NUCLEAR REGULATORY COMMISSION

Title: Advisory Committee on Reactor Safeguards
 Fukushima Subcommittee Meeting
 Flooding Hazard Reevaluation

Date: Friday, April 22, 2016

FE Path 1: Bounded Flood Mechanism

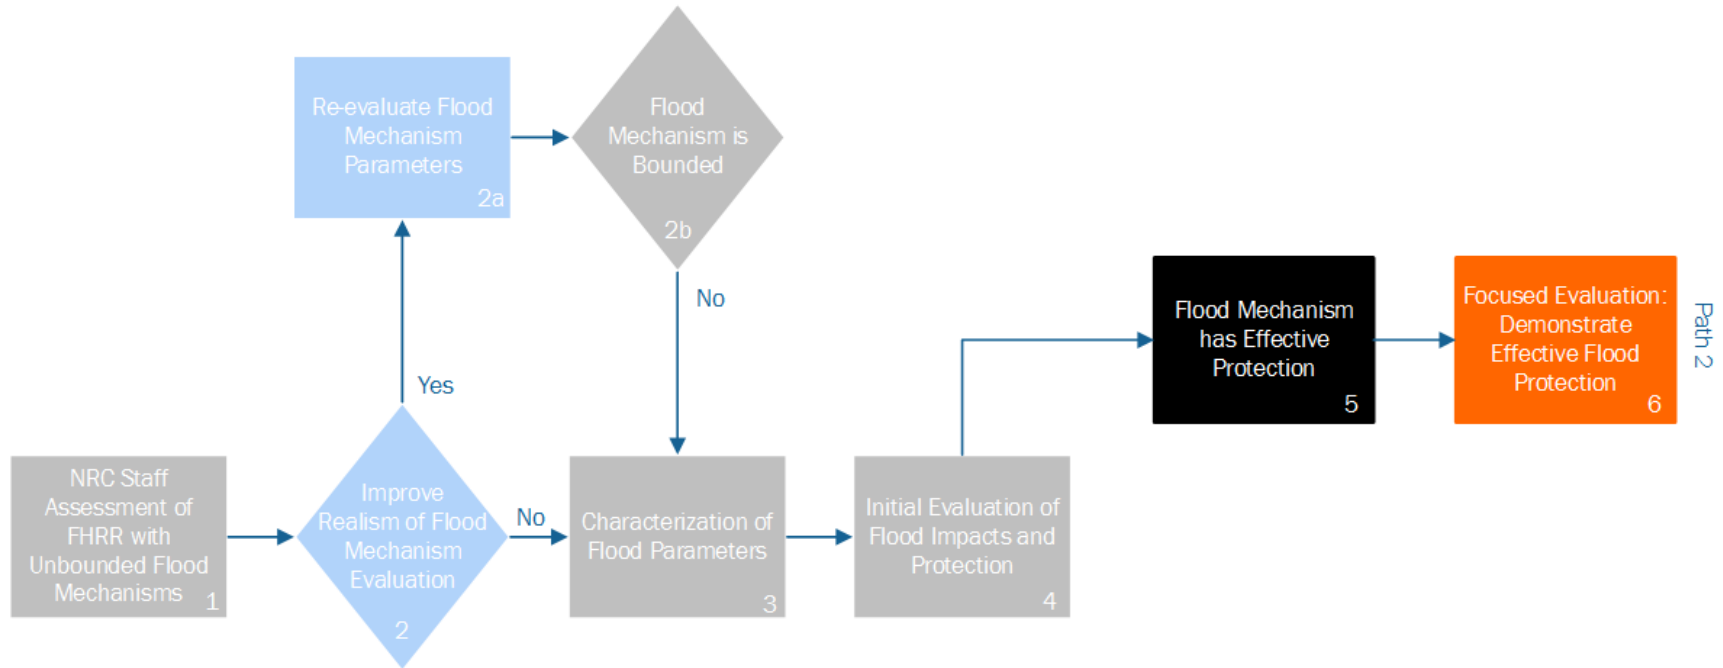
1 MEMBER SKILLMAN: Tom, how do you, not
2 you, how does this process account for uncertainty?
3 Identifying how much margin you have presumes that
4 you know if you will the acre-feet of water, the
5 location of your component, how high the component
6 is relative to other components. So my question is
7 how do you account for uncertainty in this riddle.

12 CHAIR STETKAR: Now can we ask the
13 questions? Your first bullet say ADemonstrate
14 available physical margin is adequate.@ You heard
15 him. His question is still on the table. I'll
16 point you to things in Appendix B that says certain
17 flood features may not lend themselves to specific
18 quantitative value but may need to be supported by
19 qualitative analysis. Things that say, ANegligible
20 or zero available physical margin can be justified
21 as acceptable if the use of conservative input
22 assumptions and/or methods in the flood hazard
23 reevaluation can be established.@

15 The idea there is that we are
16 addressing uncertainties what can be established as
17 overly conservative, unrealistically conservative,
18 inputs or methods or assumptions. So maybe an
19 example might be helpful. If you assume 50 dams in
20 a watershed fail at the same time and are
21 artificially located just upstream from the plant.

1 uncertainty is really not a relevant question
2 because you're clearly using a very unrealistically
3 conservative assumption when establishing that
4 mechanism. Somebody could make that case and use
5 that first bullet and deal with the margin that way
6 as adequate.

FE Path 3: Feasible Response to LIP

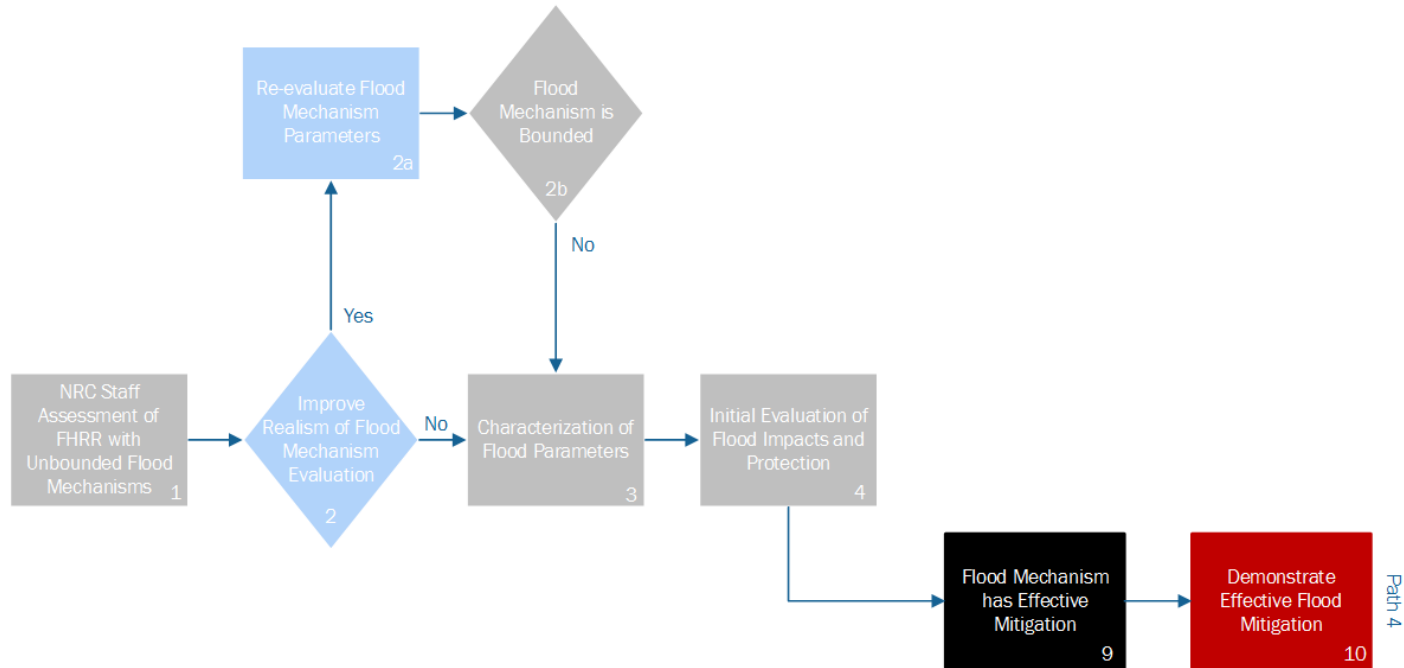
20 CHAIR STETKAR: Now my question is in
21 this construct now -- it's now 2016 -- and we had
22 different paths and different ways of dealing with
23 these things, why can't I do what smells like a
24 path two assessment for local intense precipitation
25 or a path four assessment for that matter if I need

17 CHAIR STETKAR: So this is simply a
18 trick to say I'm not never going to look from a
19 regulatory perspective at mitigation of local
20 intense precipitation. Is that correct?

14 MR. SHAMS: You could have a path two
15 assessment for local intense precipitation if you
16 have plant protection that's able to withstand that
17 hazard, yes. That would be equivalent. You still
18 call it a three, but nonetheless you're
19 demonstrating that the plant protection are able to
20 withstand that hazard.

19 MR. KENNY: This is Joe Kenny from
20 Research. Getting back to your original question,
21 fundamentally there is no reason why you couldn't
22 handle local intense precipitation by one of the
23 other paths. But there are a couple key points
24 about local intense precipitation which lend it to
25 having its own path. And fundamentally though one

1 is the ability to forecast a LIP event which is not
2 nearly as well developed as our ability to forecast
3 other large scale flooding events and (2) also the
4 impact, the duration, of that event on the plant is
5 going to be most of the time very, very short
6 compared to the other large scale flooding events
7 that we're concerned about.

IA Path 4: Effective Flood Mitigation

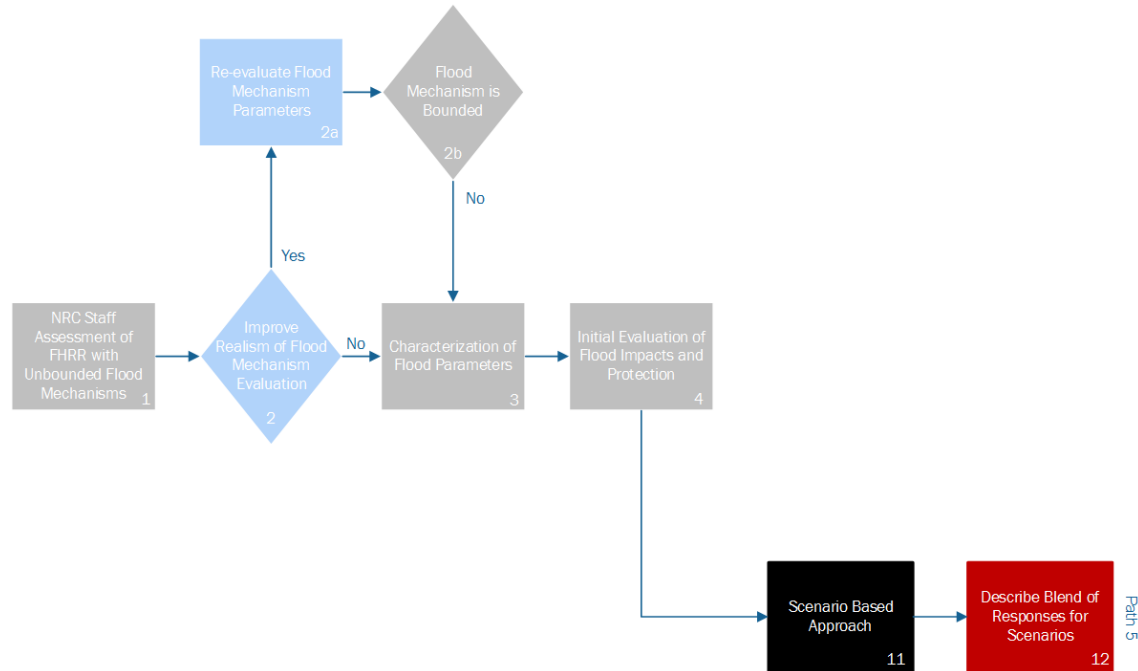
20 CHAIR STETKAR: But there is this --
21 You spoke this morning. In path four, it seems
22 that because they're deemed to be more frequent or
23 whatever the words are in the guidance there is the
24 onus to provide confidence that the mitigating
25 strategies are both feasible and reliable.

12 CHAIR STETKAR: A Demonstrate overall
13 response is adequate.@ Now you're careful to use
14 words like effective flood mitigation applies for
15 path four while feasible mitigation applies for
16 path five. And I'm trying to understand what you
17 mean by that.

1 MR. TSCHLITZ: Feasible plus what we do
2 in Appendix C for effective flood mitigation for
3 path four is what we're saying is adequate, an
4 adequate overall site response. I don't know
5 whether we want to get into discussion of that now
6 or whether we want --

19 MR. MILLER: This is Drew Miller
20 representing Exelon. I think what Appendix C is
21 that it uses that as a starting point. And it's
22 really designed to evaluate manual actions to carry
23 out the site response in response to an external
24 flooding mechanism. And any of the paths are going
25 to use this appendix if you have manual actions
